<b>30" C.E. WHITE BARRIER WELD REPAIR</b>		<b>RECALL # 05V-255</b>	
<b>BY:</b> Jose Vazquez	<b>DEPARTMENT:</b> Warranty	<b>DATE:</b> 3/4/2010	<b>REVISION:</b> 3

2000- 2006 US Bus Corporation Sturdibus School Buses

Figure B

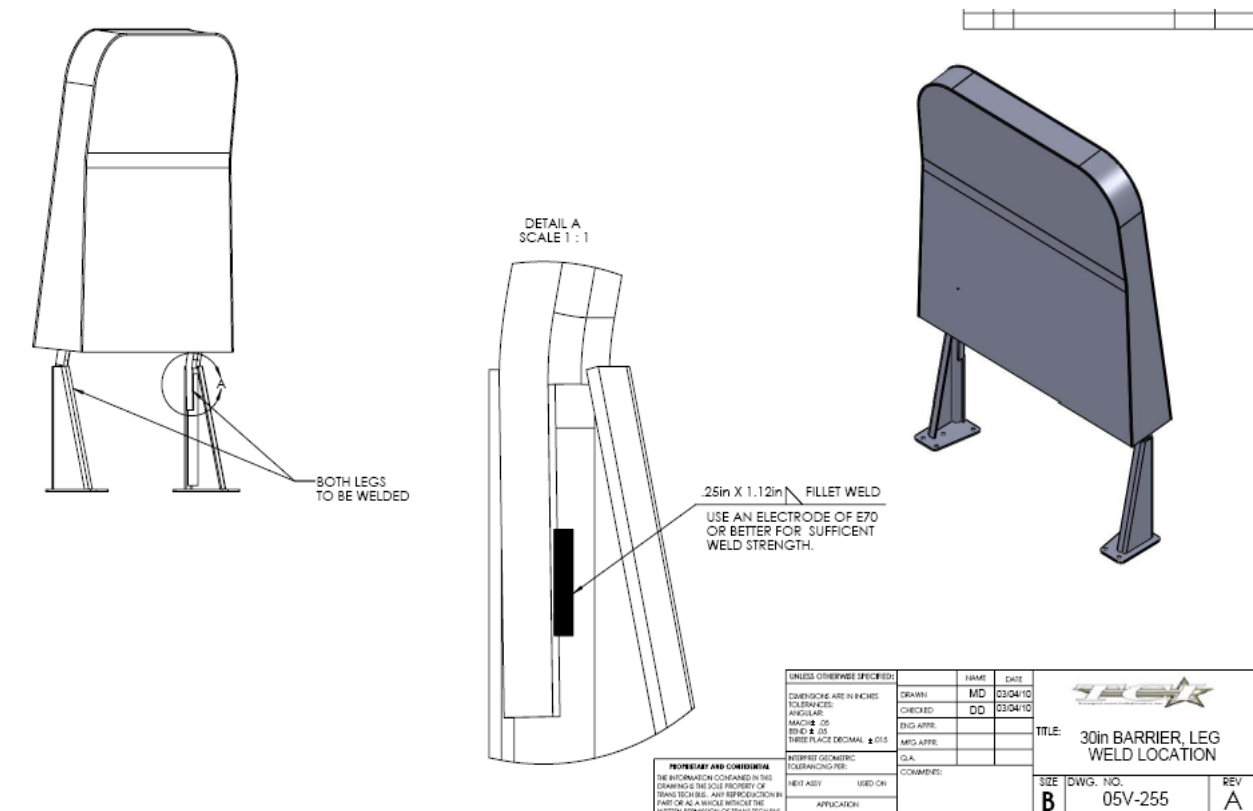
The non-compliance relates to failure of the Forward Impact Barrier, manufactured by C.E. White Corporation, to absorb the required level of energy within the deflection range, as defined by Federal Motor Vehicle Safety Standard No. 222 "School Bus Passenger Seating and Crash Protection". The 30-inch barriers frames were manufactured incorrectly, whereby certain critical welds were not performed in critical areas.

- 1) Locate the barrier floor leg section that consists of a 1" outside diameter round tube extending down from the upholstered back, a formed metal boot in the shape of a "C" that is approximately 11.75" tall, a flat footpad with a series of holes to mount the leg to the floor, and a 7 gage x 0.75" flat steel plate that extends down from the upholstered back and extends approximately 1.50" beyond the top of the boot. This area is fully exposed below the upholstery line and should be very visible.
- 2) At the end of the flat steel plate below the top of the boot, there should be a 0.75" weld across the bottom and extending vertically up the backside by at least 0.38", Otherwise there should be 1.12" of vertical weld at the seam of the plate and tube on the backside of the barrier frame. If this amount of weld is not present, then proceed to the Repair Steps and follow instructions.

- 1) With proper heat and fire protection surrounding weld area either keep barrier in vehicle or remove barrier from vehicle before following the next weld steps.

Warning: All flammable and soft good materials must be protected from weld splatter and heat of weld before proceeding,

- 2) Prepare the seam for weld between the end of the flat plate and round tube by removing all paint from surface using a wire wheel on the end of an air, battery or electric hand tool,
- 3) With proper welding equipment, place a 1.12" length of vertical weld along the backside of the barrier frame at the seam location shown in figure "A". Use an electrode of E70 or better for sufficient weld strength.
